Extending S-Parameters Mask Range

(Comments 363, 364, 367, 348)

**IEEE 802.3dj Plenary Meeting
Madrid Spain**

Comment 363 and 367

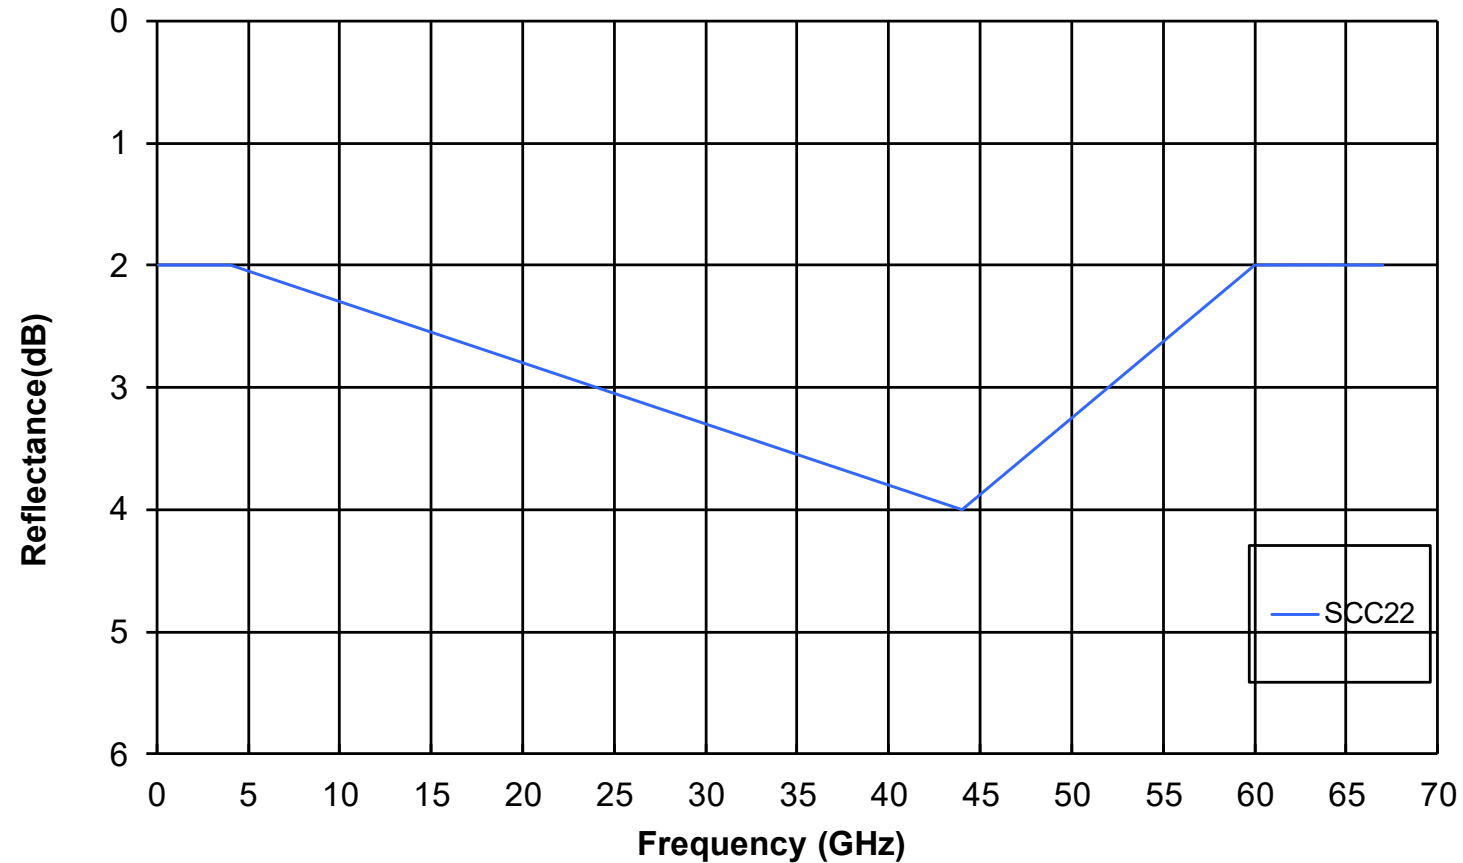
- ❑ Extend RLcc (clause 179) and RLcc (clause 178) range from 60 GHz to 67 GHz as shown below.

Comment 364

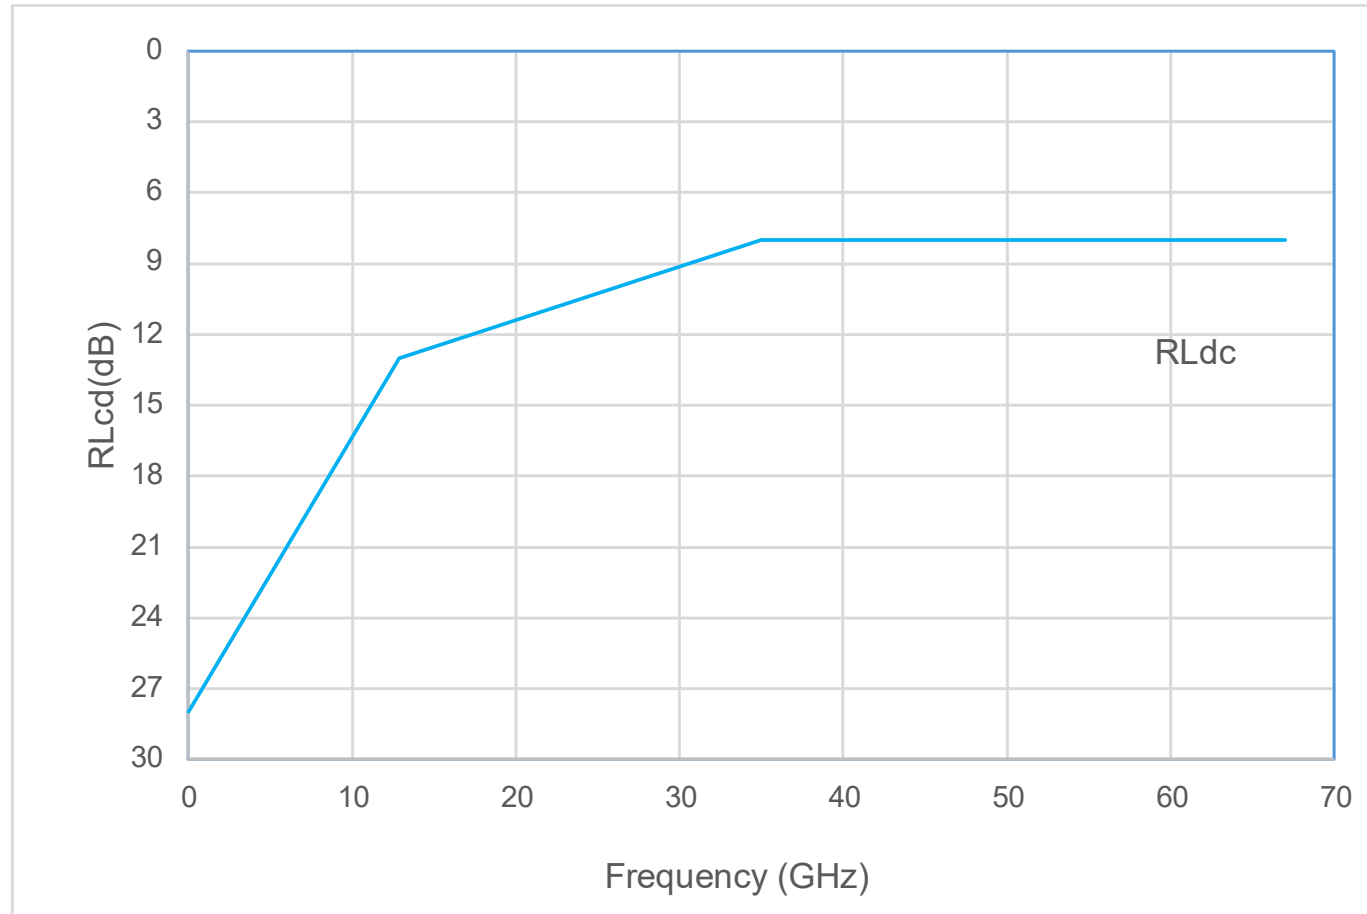
- Extend RLcd (clause 179) range from 60 GHz to 67 GHz as shown below.

MTF RLdc11 and RLdc22

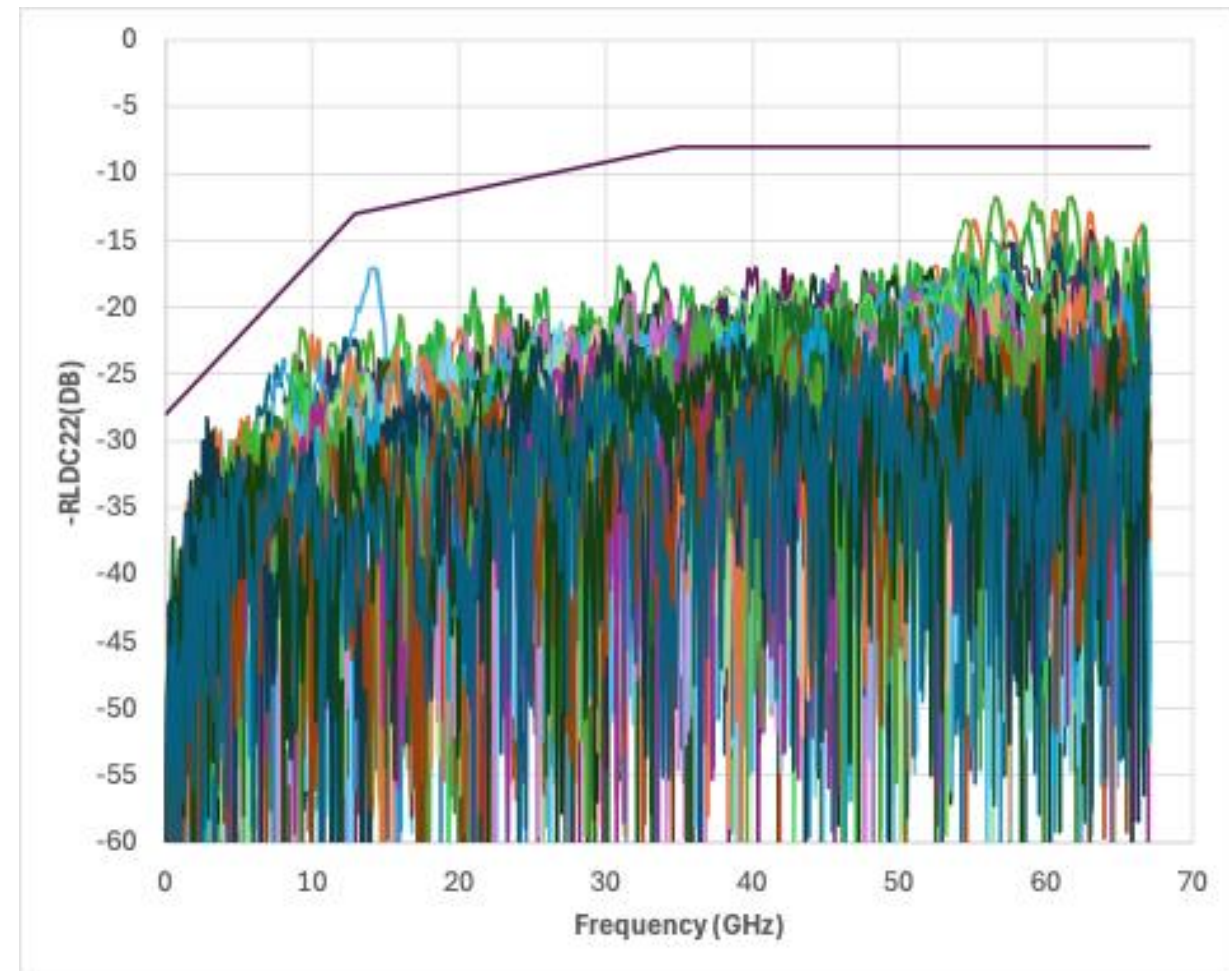
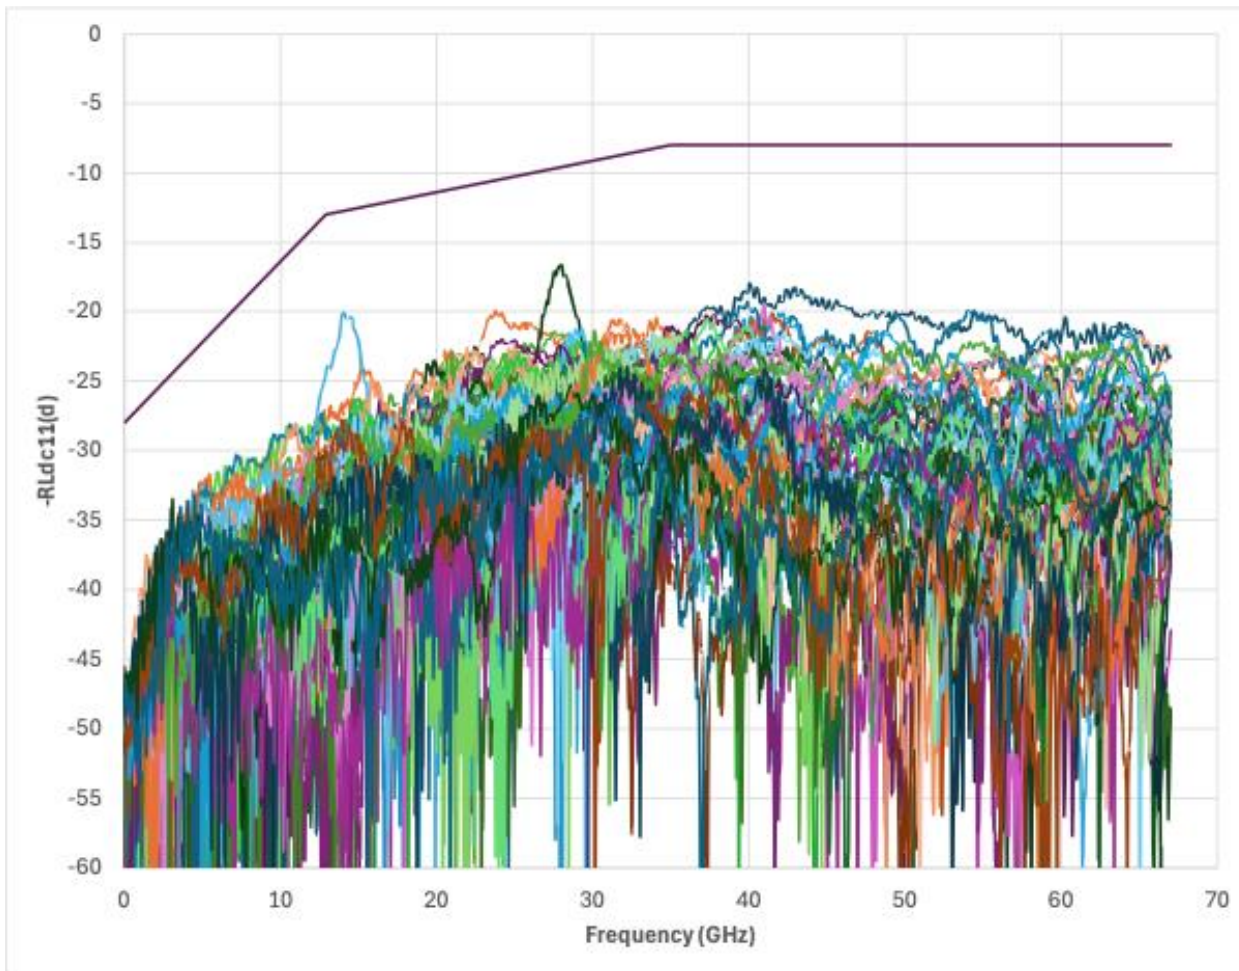
- Recommendation is to extend MTF RLcd -10 dB at 60 GHz to 67 GHz
 - Recommendation is to extend MTF RLcc -3 dB at 60 GHz to 67 GHz
 - Limit may need some further adjustment after $Z_0=92.5\ \Omega$ consideration.
